## Korenix JetNet PoE Switch- JetNet 4706 SOFTWARE RELEASE Notes

### About This Software Version

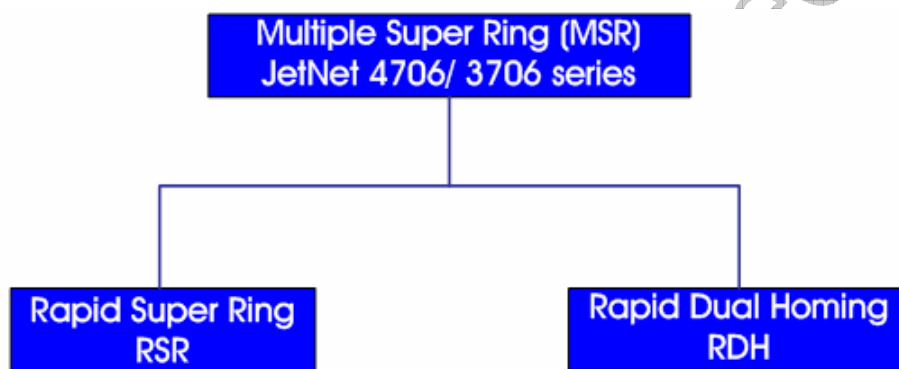
- Fix fault reply wrong action issue when the trigger event sets to port link event and the relay will active with wrong port link status.
